## Testimony Regarding Montgomery County Department of Permitting Services Proposal to Adopt the 2012 International Residential and Energy Conservation Codes

The Montgomery County Energy and Air Quality Advisory Committee intends to submit a detailed testimony before the record of this hearing closes. Today we submit a summary of that testimony.

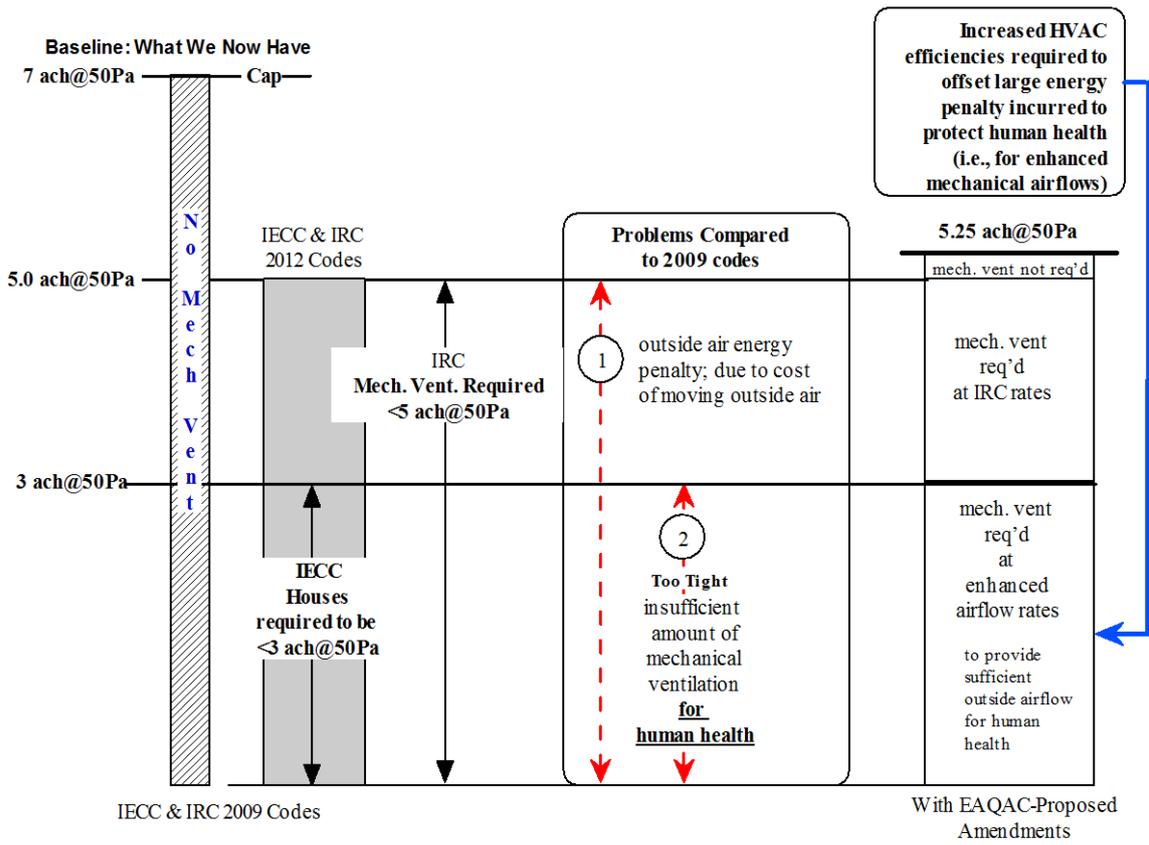
It is essential to provide builders with options for housing shells having different tightness. Since the tightness must be assessed after the house is built, builders must have options so that they can meet code even if the measured tightness differs somewhat from the tightness they proposed at the design stage. We propose that builders be allowed three options, which differ with respect to “tightness” of the homes they build.

1) “No mechanical air” option – This is our preferred option because it achieves adequate ventilation at the lowest cost (and greatest energy savings)

This option would apply to houses in the tightness range 5.0-5.25 ach@50Pa. This option would allow a builder not to have to install mechanical ventilation equipment and for the homeowner not to have to pay an increased operating cost for the electricity to run such equipment. This option would provide the house with sufficient outside air for human health purposes. It would be allowed by amending the IECC and IRC requirements to allow homes with tightness up to 5.25 ach@50 Pa.

2) “Small mechanical air” option - The option is the closest to the current proposed codes

This option would apply to houses in the tightness range 3.0-5.0 ach@50Pa. In this option, houses would have to have whole-house mechanical air and the amount of mechanical air would be as specified in the IRC-2012 Table M1507.3.3 (1). In this range of building tightness, there would be sufficient total mechanical and infiltrated air to provide for human health. This option entails a net energy penalty (relative to option 1) for using electricity to run a mechanical ventilation system. This option would require amendments to the IRC and to the IECC.

3) “Big mechanical air” option – This option achieves the “tightest” house but with the biggest energy penalty. This large energy penalty needs to be offset and we propose how to do this. It requires additional mechanical ventilation beyond that specified in 2012 IRC.

This option would apply to houses in with tightness < 3.0 ach@50 Pa. The amount of mechanical air called for in IRC-2012 Table M1507.3.3 (1) is too small by 23-36%, depending on the tightness of the building. For such houses a modified form of Table M1507.3.3 is needed to meet human health needs. Insofar as the net energy penalty for using a larger airflow mechanical ventilation system would be larger, this option would require an additional energy demand action to offset this net energy penalty. We propose that the county amend the IECC to explicitly permit builders to install heating and cooling equipment that exceeds prevailing federal minimum efficiencies. We propose changes to both the Prescriptive and Performance options found in the IECC-2012 to accomplish this purpose.
